From: Jim Letner <[jimletner@hotmail.com](mailto:jimletner@hotmail.com)>  
Sent: Wednesday, April 29, 2020 2:00 PM  
To: Lacock Fletcher <[Fletcher.Lacock@rcgov.org](mailto:Fletcher.Lacock@rcgov.org)>  
Cc: Fisher Vicki <[Vicki.Fisher@rcgov.org](mailto:Vicki.Fisher@rcgov.org)>; Jake Quasney <[Jake.Quasney@lloydcompanies.com](mailto:Jake.Quasney@lloydcompanies.com)>;  
[luke.neely@lloydcompanies.com](mailto:luke.neely@lloydcompanies.com)  
Subject: Re: 20PD010 - Revised plans

**The Vue at Catron**  
**LAYOUT PLAN**

**C4 REV 01**

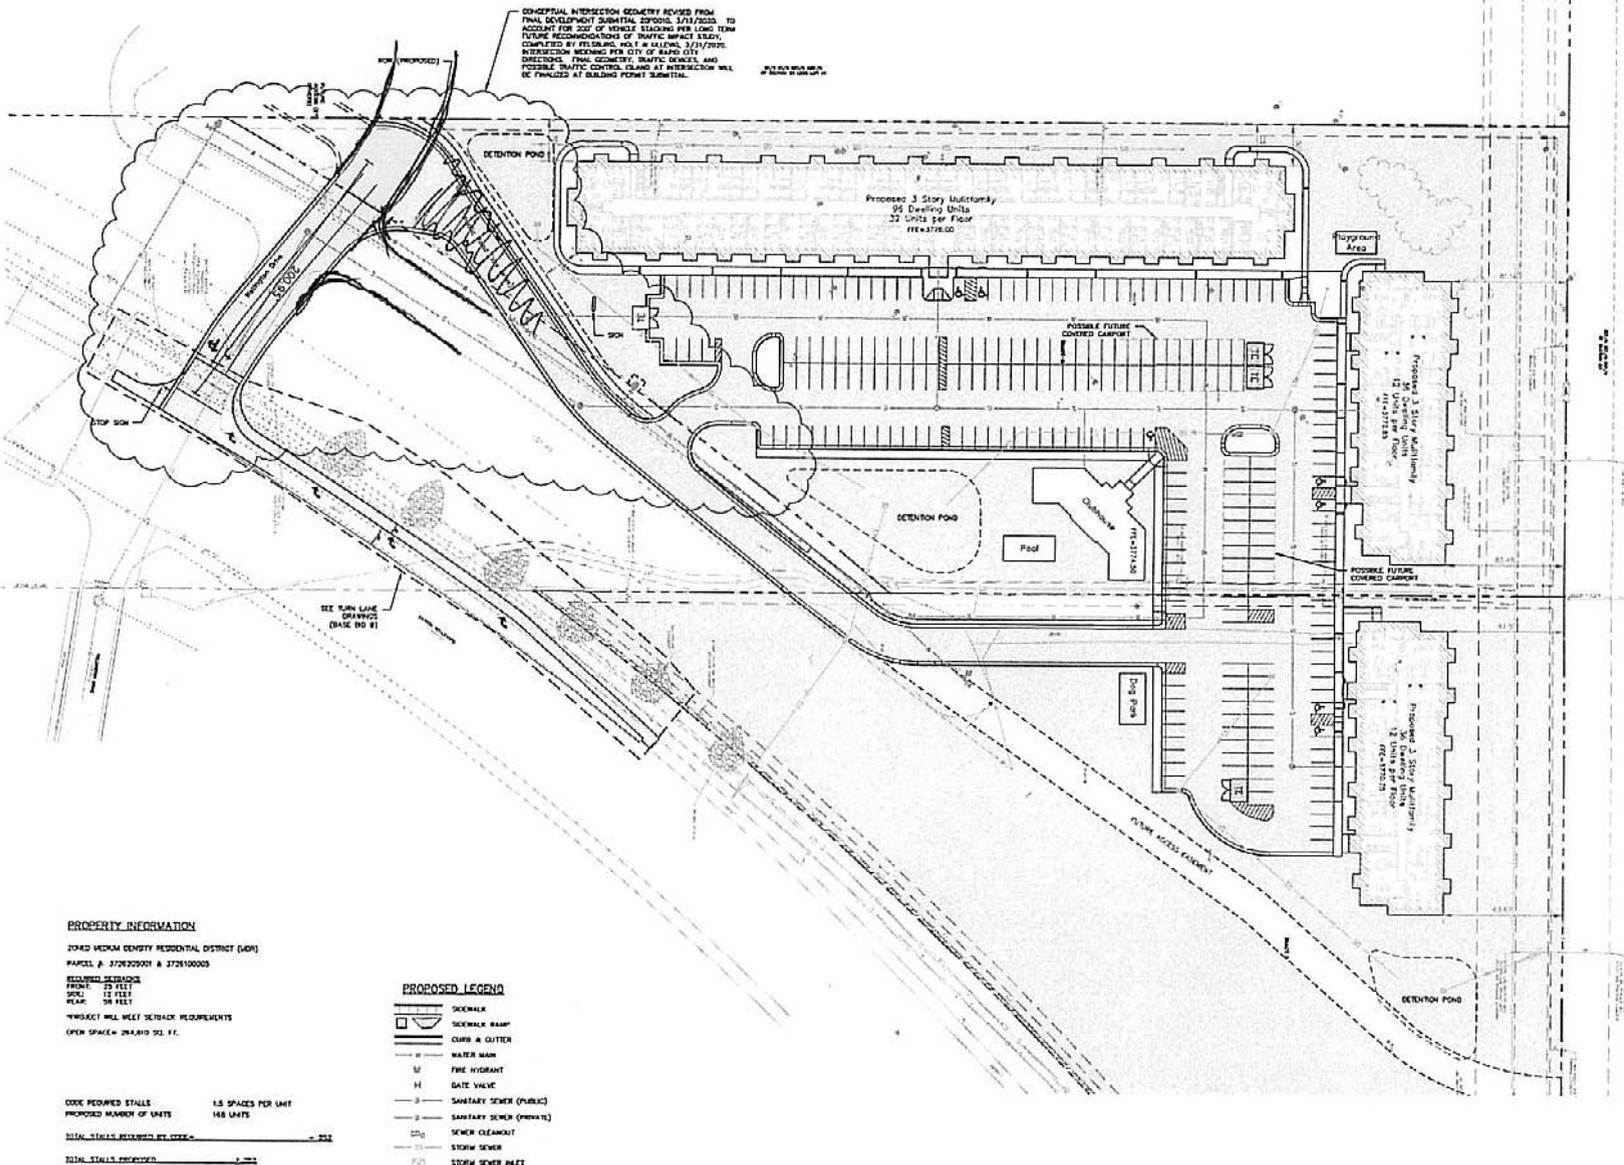
I think that I'm ok with that. I'm also OK if they use the existing street but, need to make a left hand turn onto Wellington. I've tried to show that in the attached drawing. As long as the vehicles leaving my property can be in the que without an oddball merge situation, I'm fine. I'll redo our site plan.
